ISSUE:	Certificate of Appropriateness for signage and alterations and Waiver of Vision Clearance	
APPLICANT:	Consolidated Petroleum, LLC	
LOCATION:	Old and Historic Alexandria District 834 North Washington Street	
ZONE:	CDX/Commercial Downtown (Old Town North)

Docket #4 BAR #2020-00035 Old and Historic Alexandria District March 18, 2020

The applicant requests a Certificate of Appropriateness to install three blade signs and number wedges on the existing dispensers and columns, replace the dispensers' decals, replace two existing wall signs, reface the existing canopy fascia, replace the dormer windows and siding, and after-the-fact approval for the roof replacement. The applicant also proposes to replace the existing pole-mounted sign with a new monument sign, as well as a Waiver of Vision Clearance for the Mobil gasoline service station at 834 North Washington Street.

PROPOSED PRICE ID SIGN MONUMENT SIGN DETAIL ILLUMINATED - LED ALLOWABLE MONUMENT SIGNAGE AREA = 20 SF PROPOSED MONUMENT SIGNAGE AREA = 16 SF

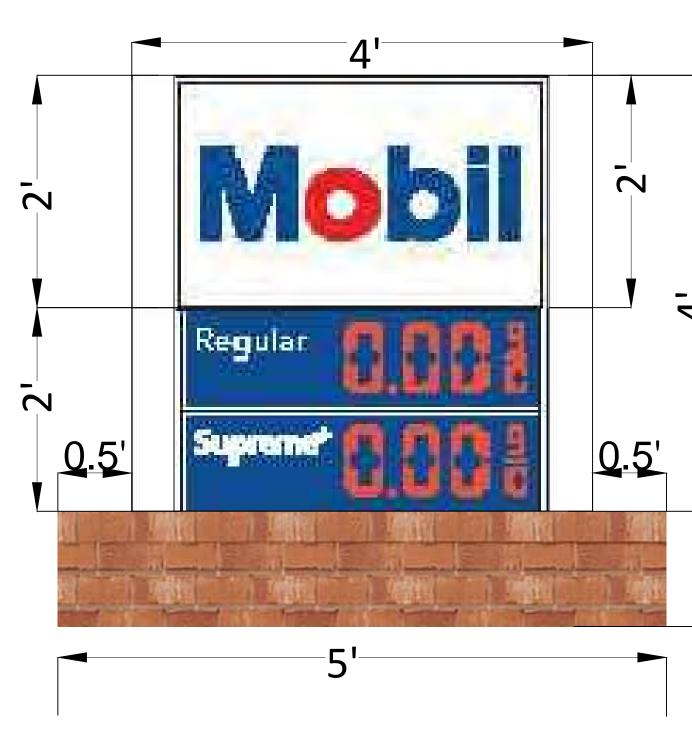
1. No signs on the site may be internally illuminated except for the price numerals on the monument sign, whose intensity is to be reviewed by staff at night in the field to ensure the compatibility of the illumination with the surrounding streetscape.

The BAR and the National Park Service (NPS) are jointly concerned with the maintenance of the memorial character of the Parkway within the City limits under a 1929 agreement between the City of Alexandria and the Federal government. Therefore, all requests for signs and new construction or alterations on Washington Street are routed to the NPS for advisory comment, as are all cases on the waterfront. The NPS submitted comments appreciating the use of a brick base on the monument sign which would provide continuity with the Parkway's historical character, but still has concerns about its illumination that, according to NPS, "is not appropriate." NPS recommends that the applicant reconsider the illumination.

- C-4 Proposed freestanding monument sign is located in the vision clearance triangle and within the required 10' setback from the front property line. Applicant must request a waiver of vision clearance from the Board and the Board may waive the 10' setback requirement per section 7-802.

C-1 A building permit and Plan review are required for illuminated monument signs.

Staff recommends that the Certificate of Appropriateness for alterations and signage, and Waiver of Vision Clearance be approved with the following conditions:
